## PCI-SIG ENGINEERING CHANGE NOTICE

<b>TITLE:</b>	Lightweight Notification (LN) Protocol
<b>DATE:</b>	Introduced: Jan 27, 2009; Last Updated Oct 2, 2011 Protocol Workgroup Final Approval: October 6, 2011
<b>AFFECTED DOCUMENT:</b>	PCI Express Base Specification version 3.0
<b>SPONSOR:</b>	Hewlett-Packard, Advanced Micro Devices

**Figure 2-x: LN Message**

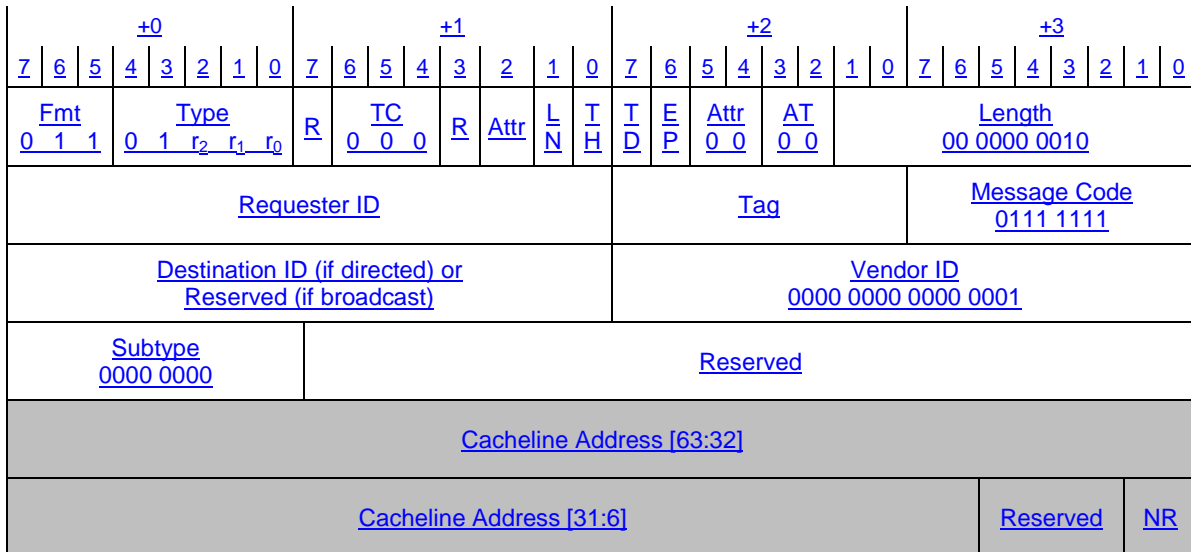
Beyond the rules for other SIG-Defined VDMs, the following rules apply to the formation of LN Messages:

- Table 2-x and Figure 2-x define the LN Messages.
- Each Message must include a 2-DWORD data payload.
- The Fmt field must be 011b (4 DW Header, with data).
- The TLP Type must be MsgD.
- The Length field must be 2.
- The TC[2:0] field must be 000b.
- Attr[2], the ID-Based Ordering (IDO) bit, is not Reserved.
- Attr[1], the Relaxed Ordering (RO) bit, is not Reserved.
- Attr[0], the No Snoop bit, is Reserved.
- Note: as with all Messages, the LN bit is Reserved. In contrast, the LN bit must be Set for LN Reads, LN Writes, and LN Completions.
- The Tag field is Reserved.
- If the LN Message is the broadcast version, the Destination ID field is Reserved.
- The Subtype field must be 00h.
- If the cacheline size in effect for the system is 128 bytes, bit 6 in the Cacheline Address must be Clear. For an LNR receiving an LN Message, if the LNR CLS bit in the LNR

Control register is Set, configuring the LNR for 128-byte cachelines, the LNR must ignore the value of bit 6 in the Cacheline Address.

- The Notification Reason (NR) field is encoded as shown in Table 2-w, indicating the specific reason that the LN Message was sent. These encodings apply to both the directed and broadcast versions of LN Messages.

**Figure 6-x: Sample System Block Diagram**

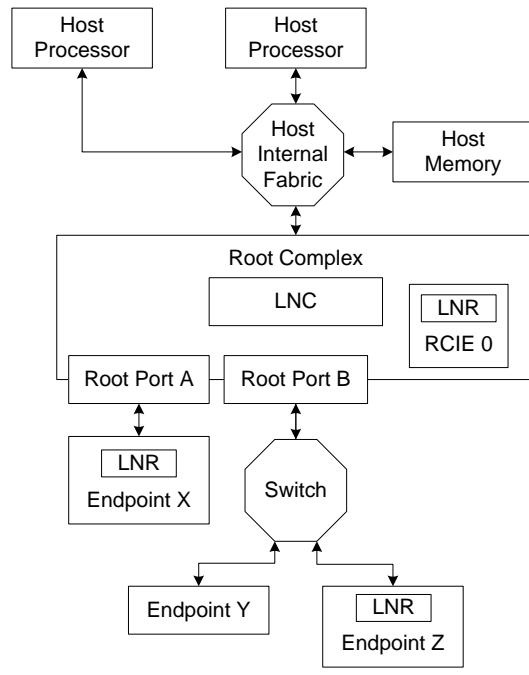
A typical system consists of host processors, host memory, a host internal fabric, Root Ports, Switches, and Endpoints. Figure 6-x below illustrates a simplified view of the elements and how they are interconnected to provide a context for describing how LN protocol operates.

In the figure above, Endpoint X, Endpoint Z, and RCIE 0 each contain an LNR. The Root Complex contains an LNC.

**Figure 6-x: LN Protocol Basic Operation**

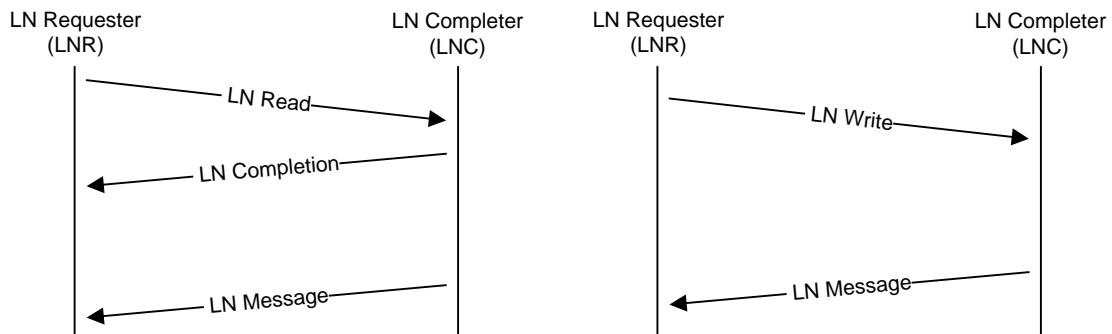
LN protocol operation with a single LNR is shown in the diagram above. For the case of reads, as shown on the left: (1) an LNR requests a copy of a line from host memory using an LN Read; (2) the LNC returns the line in an LN Completion and records that the LNR has registered the line; and (3) the LNC later notifies the LNR using an LN Message when the registered line has been updated. For the case of writes, as shown on the right: (1) an LNR writes to a line to host memory using an LN Write; (2) the LNC records that the LNR has registered the line; and (3) the LNC later notifies the LNR using an LN Message when the registered line has been updated.

Figure 7-25: Device Capabilities 2 Register

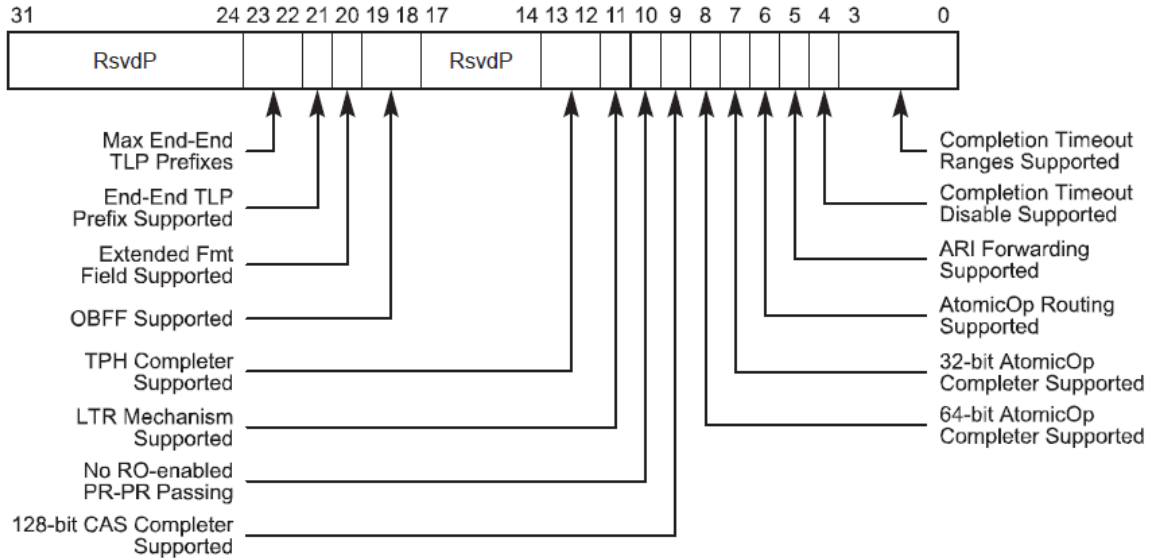
Note to Editor: modify Figure 7-25 to reflect the new field defined below:

Bit Location	Register Description	Attributes
...	...	...
<a href="#">15:14</a>	<p><a href="#">LN System CLS – Applicable only to Root Ports and RCRBs; must be 00b for all other Function types. This field indicates if the Root Port or RCRB supports LN protocol as an LN Completer, and if so, what cacheline size is in effect.</a></p> <p><a href="#">Encodings are:</a></p> <ul style="list-style-type: none"> <li><a href="#">00b</a> LN Completer either not supported or not in effect</li> <li><a href="#">01b</a> LN Completer with 64-byte cachelines in effect</li> <li><a href="#">10b</a> LN Completer with 128-byte cachelines in effect</li> <li><a href="#">11b</a> Reserved</li> </ul>	<a href="#">HwInit</a>
